Docket Item #25  
DEVELOPMENT SPECIAL USE PERMIT #2003-0039  
Pentagon Federal Credit Union

Planning Commission Meeting  
May 4, 2004

**ISSUE:** Consideration of a request for a development special use permit, with site plan, for construction of an office building.

**LOCATION:** 2930 Eisenhower Avenue

ATC V, VI and VII Site Plan

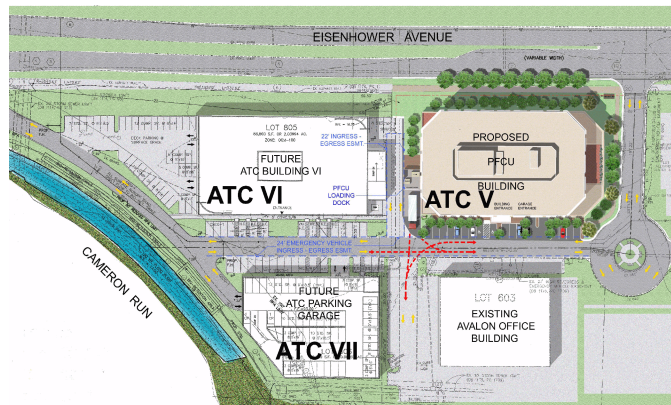
The proposal will provide an 8 ft. wide concrete pedestrian walkway at the southern portion of the site, a 6 ft. wide concrete pedestrian walkway at the eastern portion of the site, and a proposed 10 ft. wide concrete sidewalk-trail connection at the northern portion of the site along Eisenhower Avenue. The proposal will also provide a bus shelter at the intersection of Eisenhower Avenue and the private access street.

- a. The proposed 10 ft. wide asphalt path shall be replaced with a 10 ft. wide concrete sidewalk-trail along Eisenhower Avenue.
  - b. Provide transparent glass at the garage entrance walls and a raised pedestrian sidewalk to provide for enhanced pedestrian circulation and safety to the satisfaction of the Directors of P&Z and T&ES.

- c. Provide a 6 ft. wide concrete sidewalk and 6 ft. wide landscape strip adjacent to the private entrance driveway on the eastern portion of the building.

*Southwest/Interior Elevation View*

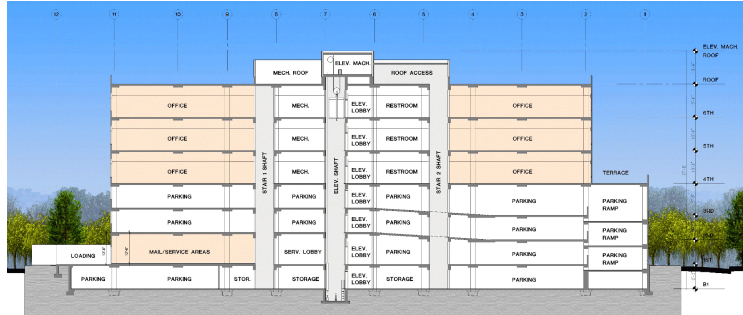
Another fundamental design difference is that the building will appear to front on Eisenhower Avenue and engage the adjoining public street rather than the current building design that has exposed parking at the first level and the facade on Eisenhower is the rear of the building.

In addition to the number of parking spaces, one of the issues raised by the current proposal is that the increased number of parking spaces equals an increase in the number of above-grade parking levels from one to three. The currently approved single level of above-grade parking is not screened and would appear as parking from Eisenhower Avenue and the remaining sides of the building. Under the current proposal, staff is recommending that each level of the parking garage provide the same level of architectural treatment and detail of as the remainder of the building to screen the parking from the adjoining streets.

- b. The facade treatment for the parking structure floors shall be concealed by high quality building materials as utilized on the upper occupied floors, which shall at a minimum consist of windows as generally depicted on the preliminary plans ;
